City of Portland, Maine - Building or Use Permit Application
 389 Congress Street, 04101 Tel: (207) 874-8703, Fax: (207) 874-8716

Permit No: 01050	Issue Date: MAY 17 2001	CBL: 389 E014001
----------------------------	-----------------------------------	----------------------------

Past Use: Single Family	Proposed Use: Same; Replace Existing 12' X 12' Deck with 14' X 22' Deck. Call John Ponger at 998-4406 when ready.	Permit Fee: \$54.00	Cost of Work: \$5,000.00	CEO District: 2
Proposed Project Description: Replace Existing 12' X 12' Deck With New 14' X 22' Deck.		FIRE DEPT: <input type="checkbox"/> Approved <input type="checkbox"/> Denied INSPECTION: Use Group: <i>A-3</i> <i>PERMIT ISSUED: 5/13</i> <i>WITH REQUIREMENTS</i>

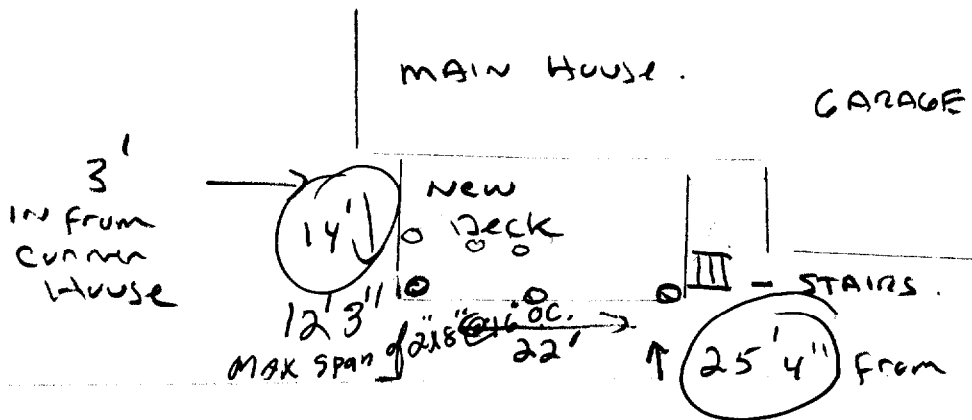
↑ 27'4" from property line

GIRDER triple 2x10
 front, ✓
 Secondary girder
 under mid left ✓
 Section triple 2x10 ✓
 6 concrete filled
 tubes 4' deep.

FRAME 16" oc 2x8 ✓
 4x4 post support girder ✓
 ledger against house with joist hangers ✓
 Solid bridging leads 16" oc to reverse deck boards ✓
 to avoid ANY splices.

STAIRS 2x12 Tread. 2x12 stringers ✓
 RAILS Around entire deck. 34" High from deck ✓
 with balusters spaced 4" APART. ✓

42
 see
 attached

check → Front: N/A
 Rear: 25' req - 25'4" shown
 Side: 12' req - appears to have 12'

<i>with condition that the side setback be 12'</i> <i>OK [Signature]</i>

32. Please read and implement the attached Land Use Zoning report requirements.
33. Boring, cutting and notching shall be done in accordance with Sections 2305.3, 2305.3.1, 2305.4.4 and 2305.5.1 of the City's Building Code. *side setback shall be a minimum of 12 feet*
